**ST. TAMMANY PARISH SCHOOL BOARD
COVINGTON, LOUISIANA**

ADDENDUM 1

**BID #1899 – RENT/LEASE OF MODULAR
BUILDINGS FOR BOYET JUNIOR HIGH**

1 ELECTRICAL RISER DIAGRAM - MODULAR BLDG

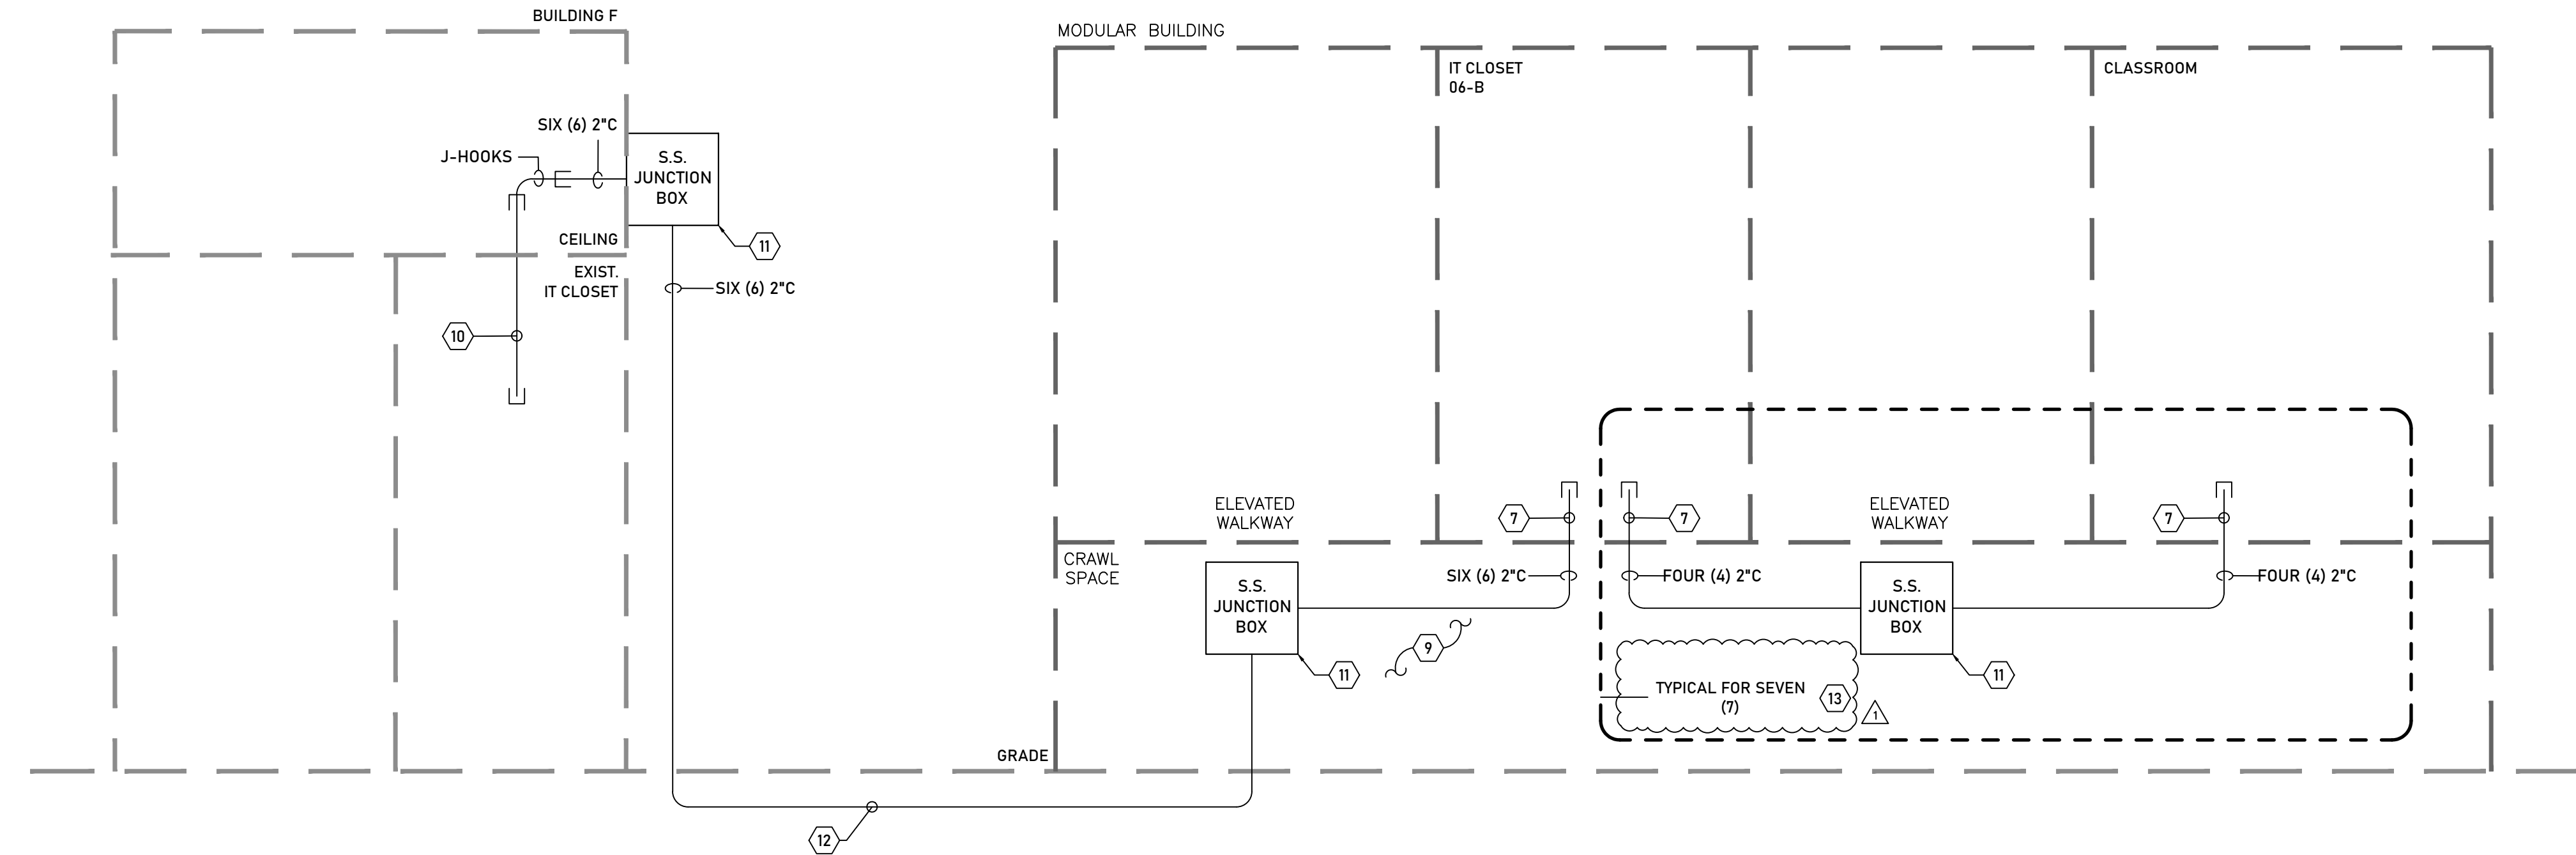
17	Building Systems	Electrical Panel Configuration – Spec vs. Drawings	Spec 2.2.k.viii; E1.01; E3.00 KN1; E4.00; E4.01	Spec 2.2.k.viii calls for (4) 100A–200A, 10KAIC, 1-phase panels. E1.01/E4.00/E4.01 show ten 100A, 120/208V, 3-phase, 4-wire panels (8 classroom, 1 office, 1 restroom) fed from a 600A MDP (22kAIC) by others. Please confirm which governs. If drawings govern, confirm: (a) 3-phase panels; (b) minimum AIC rating / available fault current at modular panels; (c) panel locations (E3.00 KN1 "dedicated panel in room"); (d) 208V single-phase HVAC units acceptable; (e) feeder entry/penetration locations coordinated with the Infrastructure Contractor (E4.00 Note 7). A17. Bid the electrical panel configuration per drawings as baseline scope. Exact manufacturer construction is unknown prior to shop drawing submittals, making drawing layouts conceptual. The selected Modular Manufacturer shall determine final panel quantities and locations. Any scope variance from baseline drawings will be reconciled during submittal review. (See attached updated electrical drawings.)

- PRE-MANUFACTURED PANELBOARD, FACTORY-INSTALLED WITHIN MODULAR BUILDING. VERIFY PANEL LOCATION WITH FINAL MANUFACTURER SHOP DRAWINGS PRIOR TO ROUGH-IN. VERIFY THE PRE-MANUFACTURED PANELBOARD IS RATED FOR 100A, 120/208V, 3-PHASE, 4-WIRE TO MATCH THE UPSTREAM FEEDER.

- DIAGRAMMATIC REPRESENTATION IS TYPICAL FOR NINE (9) PRE-MANUFACTURED, FACTORY-INSTALLED PANELBOARDS SERVING THE MODULAR BUILDINGS: EIGHT (8) PANELS FOR CLASSROOMS, AND ONE (1) PANEL FOR RESTROOMS, PANEL LAYOUT, QUANTITIES, AND DESIGNATIONS SHOWN ON SHEET E1.01 ARE FOR REFERENCE ONLY. CONTRACTOR SHALL VERIFY EXACT PANEL QUANTITIES, RATINGS, AND LOCATIONS WITH FINAL MODULAR MANUFACTURER SHOP DRAWINGS PRIOR TO ROUGH-IN.
